STAFF RECOMMENDATION
255 Cherokee Road
August 19, 2015

Application: New construction—addition
District: Cherokee Park Neighborhood Conservation Zoning Overlay
Council District: 24
Map and Parcel Number: 10308021000
Applicant: Michael Ward, Architect
Project Lead: Melissa Baldock, melissa.baldock@nashville.gov

Description of Project: Application is to construct a one-story addition that is wider than the historic house.

Figure 2. 255 Cherokee Park is shifted significantly to the right side of the lot.

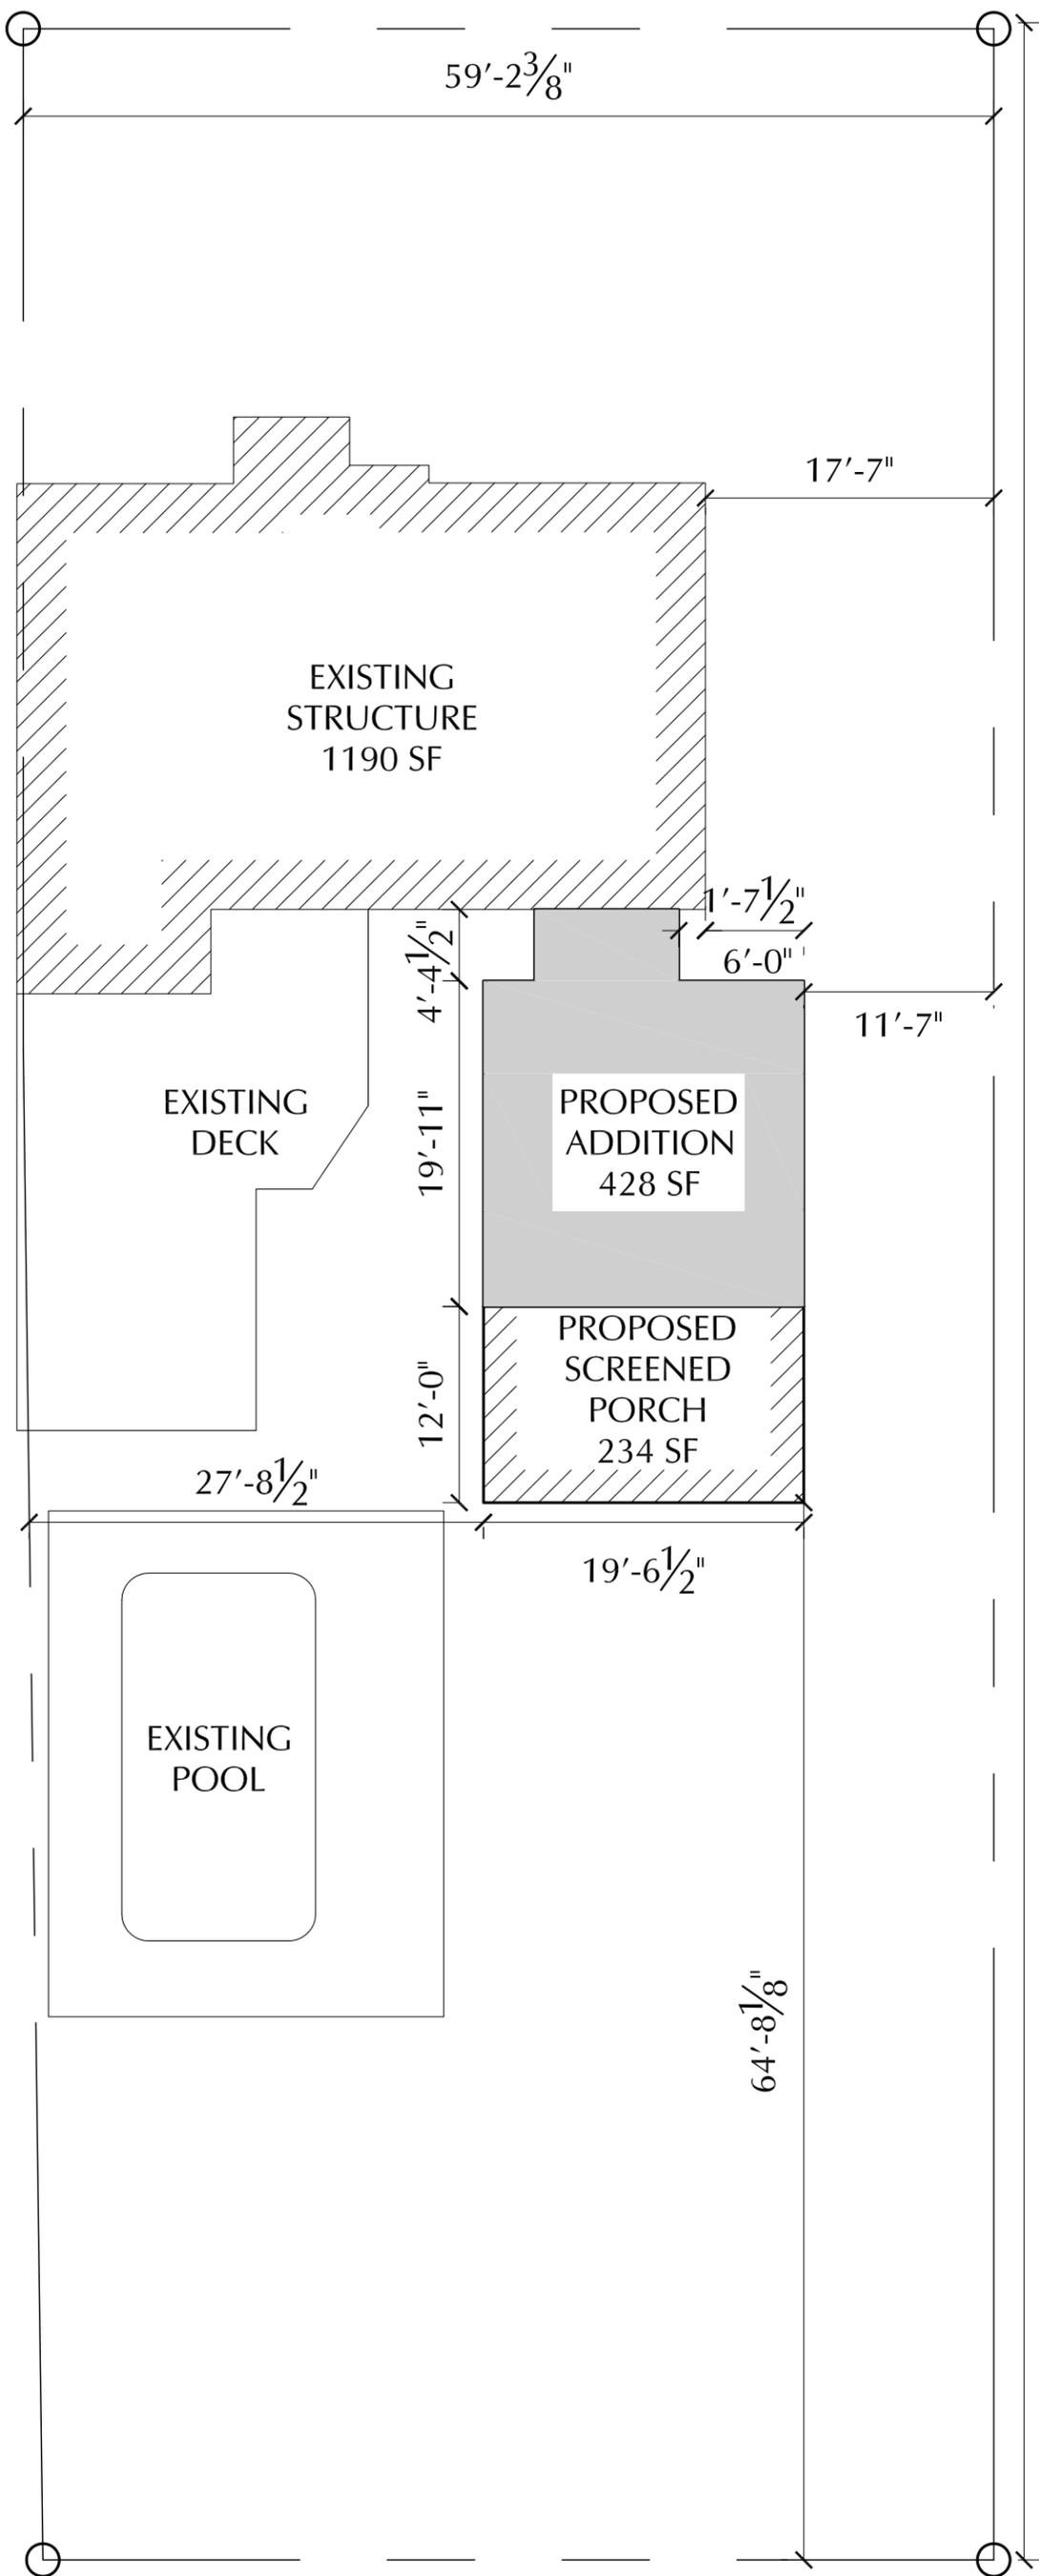
The addition will be inset approximately one foot, seven and a half inches (1'7.5") from the back left corner of the house. It is inset over thirty feet (30') from the right side of the house. The addition does not extend to be six feet (6') wider than the historic house on the left side. Staff finds the extra width to be appropriate for several reasons. The addition preserves the back corners of the house by stepping in from the back walls before extending to be wider than the house. In addition, the house is shifted significantly on the lot so that it sits on the right property line and is over seventeen feet (17') from the left property line (Figure 2). The rhythm of the street will not be disturbed since this building is at the end of a dead-end street and does not have buildings across the street which face

it. Lastly, the addition is subordinate to the primary massing by being significantly shorter than the primary massing and having such a minimal amount extending beyond the side wall of the primary massing. The addition will add six hundred and sixty-two square feet (662 sq. ft.) to the one thousand, one hundred and ninety square foot (1,190 sq. ft.) house.

Site Plan

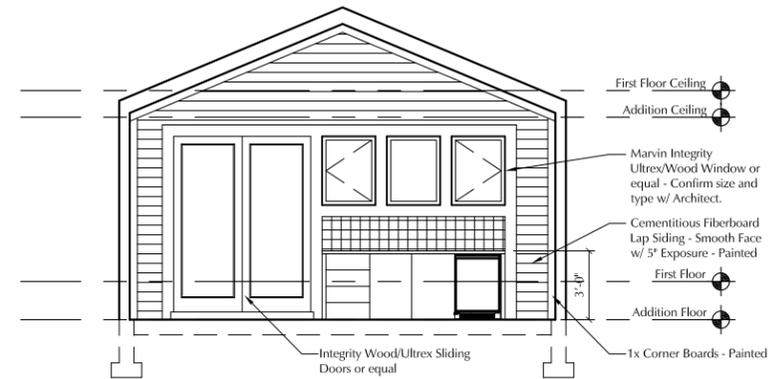
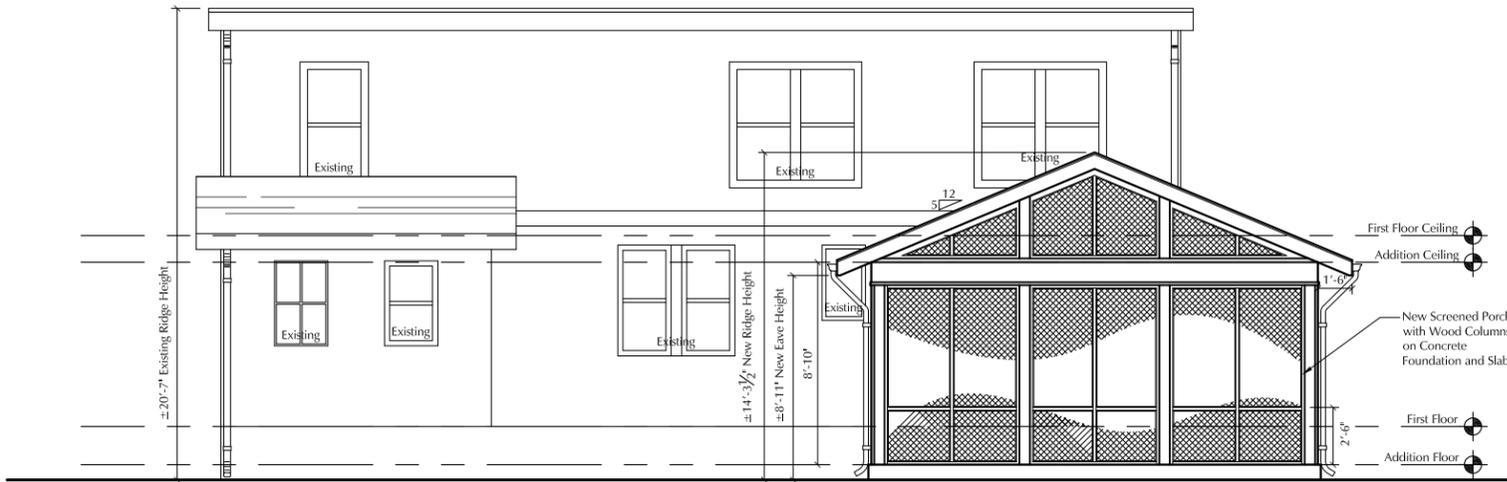
Setback & Rhythm of Spacing: The addition meets all base zoning setbacks. It is over eleven feet (11') from the left side property line, twenty-seven feet (27') from the right side property line, and sixty-four feet from the rear property line. Even though the addition is wider than the historic house, it still preserves the rhythm of spacing of houses in the immediate context. Staff finds that the addition meets Sections II.B.1.c. and II.B.2. of the design guidelines

Appurtenances & Utilities: No changes to the site's appurtenances were indicated on the drawings. The location of the HVAC and other utilities was also not noted. Staff asks that the HVAC be located on the rear façade, or on a side façade beyond the midpoint of the house. The project meets Sections II.B.1. i. and II.B.2. of the design guidelines

1. Staff approve the final details, dimensions and materials of windows and doors prior to purchase and installation; and,
2. The HVAC shall be located behind the house or on either side, beyond the midpoint of the house.

Drawings:
 West Elevation
 South Elevation
 Date:
 08.03.15

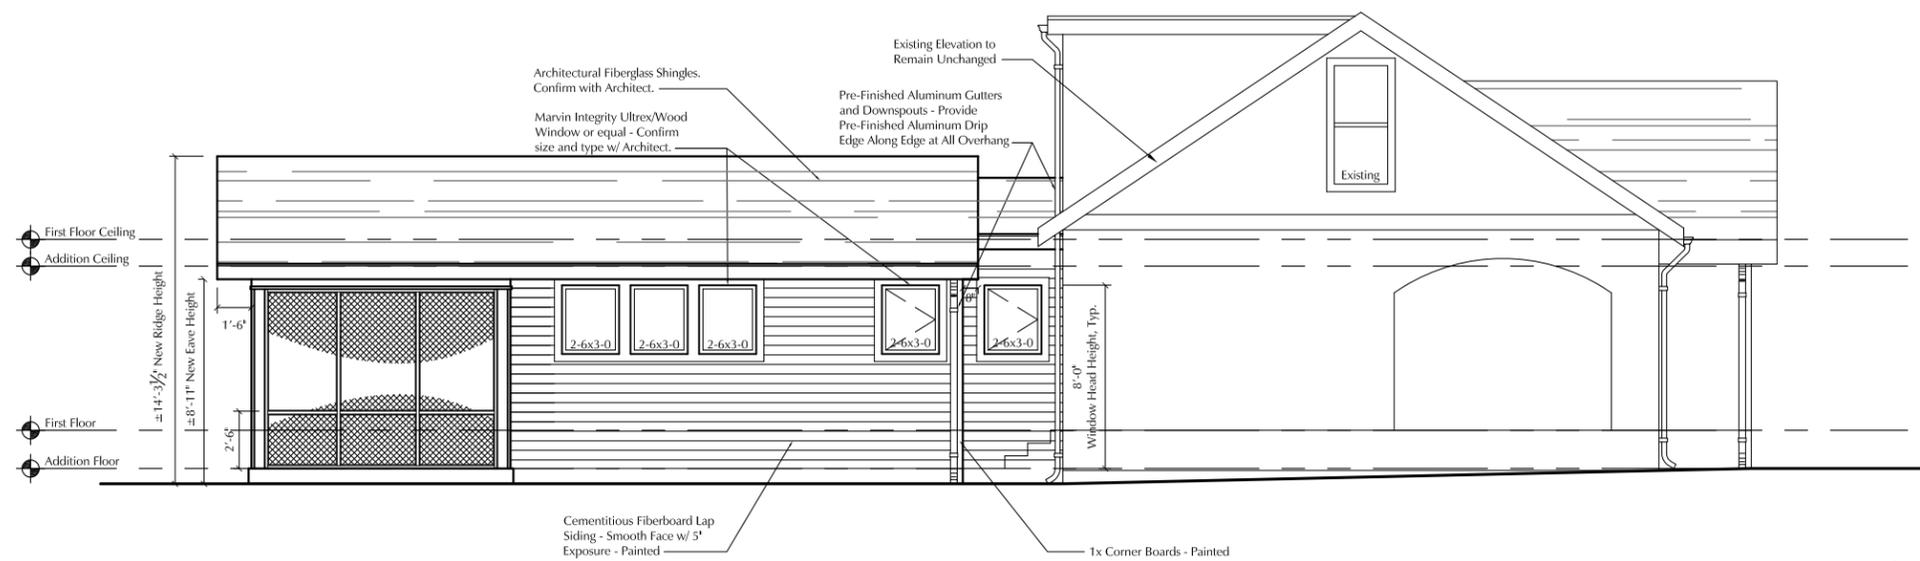
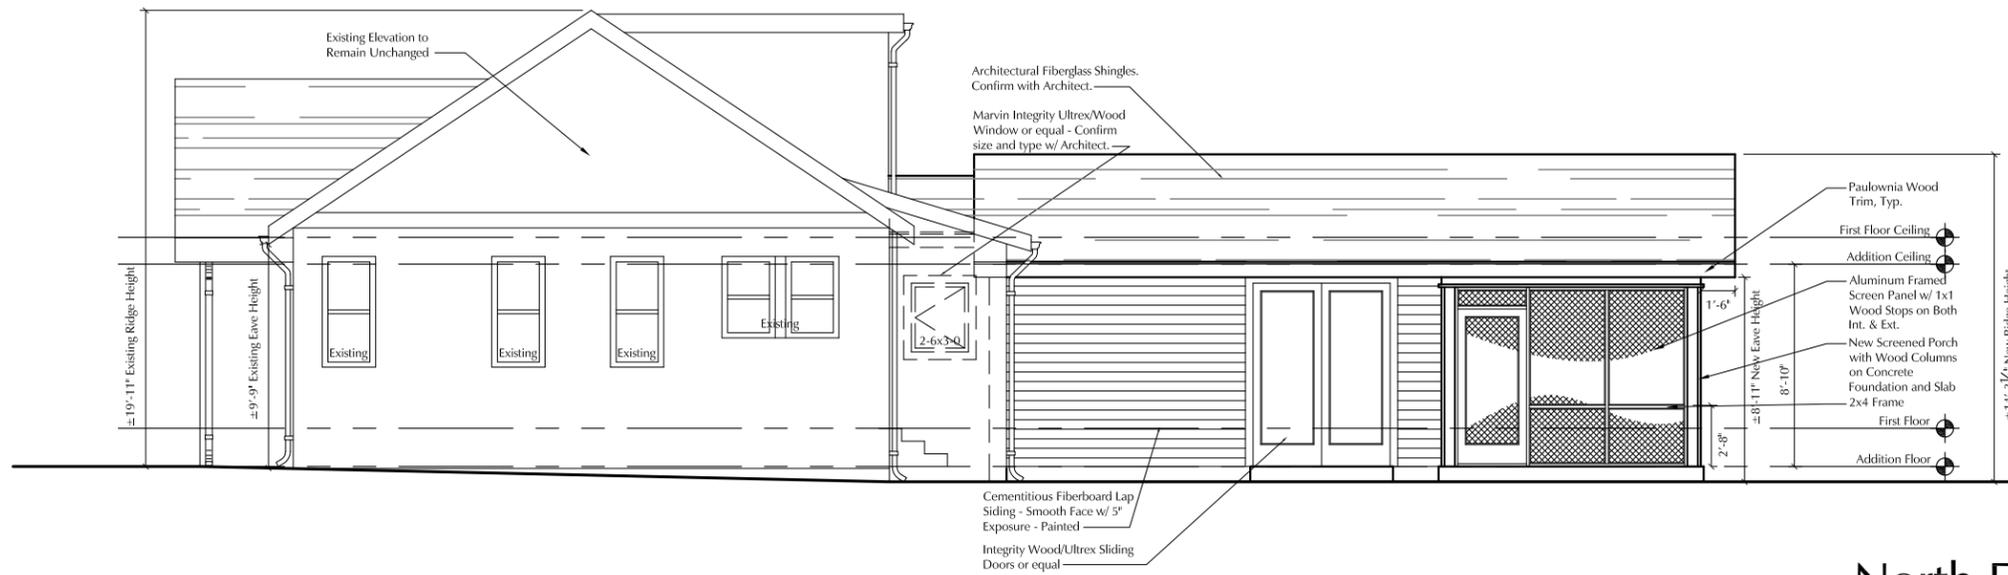
Height & Scale: The one-story addition is approximately six feet (6') shorter in height than the historic house. Its eave height will be approximately nine feet (9'), which is lower than the existing house, and its ridge height will be approximately fourteen feet, six inches (14'6"). The addition's foundation height will match that of the historic house.

Roof form: The historic house has a side gabled roof form with an 7/12 pitch. The proposed addition will have a front-facing gable with a slope of 5/12. Staff finds that the proposed roof form helps to keep the height of the addition subordinate to the historic house. Staff finds that the addition meets Sections II.B.1.e. and II.B.2. of the design guidelines.

Proportion and Rhythm of Openings: No changes to the window and door openings on the existing house were indicated on the plans. The windows on the proposed addition are two feet, six inches (2'6") wide by three feet (3') tall. Although the windows are not twice as tall as they are wide, staff finds them to be appropriate because they will not be highly visible from the street. There are no large expanses of wall space without a window or door opening. Staff finds the project's proportion and rhythm of openings to meet Sections II.B.1.g. and II.B.2. of the design guidelines
